UNITED STATES PATENT AND TRADEMARK OFFICE

Office Action Summary

10/722,859

DETAILED ACTION

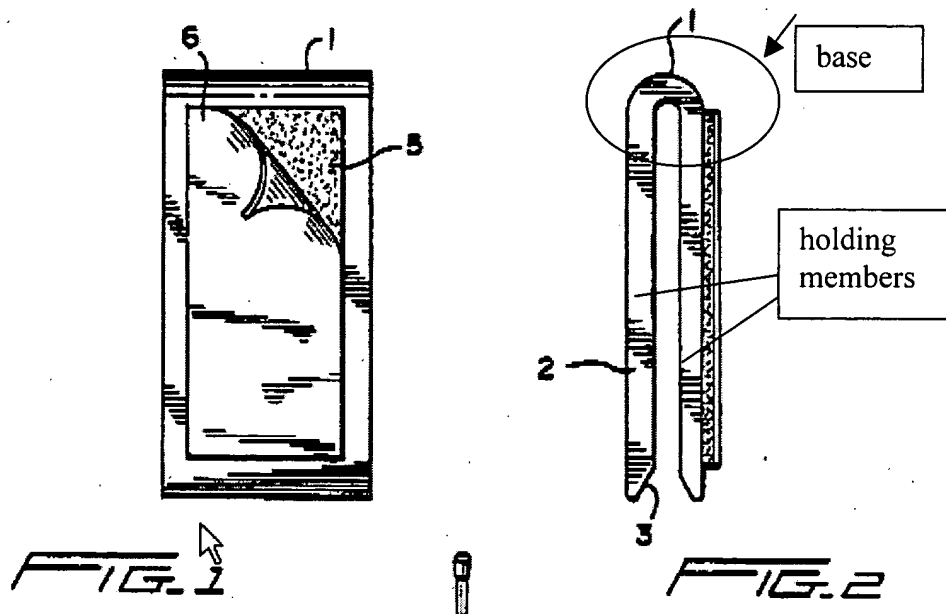
Concerning claims 1, 4, 5, 8, 9, 14, 16, 19, 20, 23, 24 and 32, Raum, Sr. ('721) discloses a holding device capable of moving a slider of a thermoplastic bag in a first direction, comprising: a base surface (see Fig. 2 provided herein), and a pair of holding members (2, see Fig. 2 provided herein) extending from the base surface and capable of being insertable over a slider in a first direction and facilitating movement of the slider in a second direction;

(concerning claims 4 and 19) at least one of the holding members or the base surface includes double-sided adhesive tape (5, 6) on an outer surface thereof;

(concerning claims 5 and 20) the holding members are capable of being spread apart;

(concerning claims 8 and 23) the holding members are spreadably apart manually;

(concerning claims 9 and 24) a notch (3) in at least one of the holding members aids a user in spreading apart the holding members manually;

Concerning claims 46, 49, 52, 60, Raum, Sr. ('721) a holding device (see Figs. 1 and 2 provided herein) comprising: a base surface; a pair of holding members (extending from the base surface; and means (end structure 3) for inserting the holding members over the slider in a first direction; and wherein the holding members being capable to facilitate movement of the slider in a second direction;
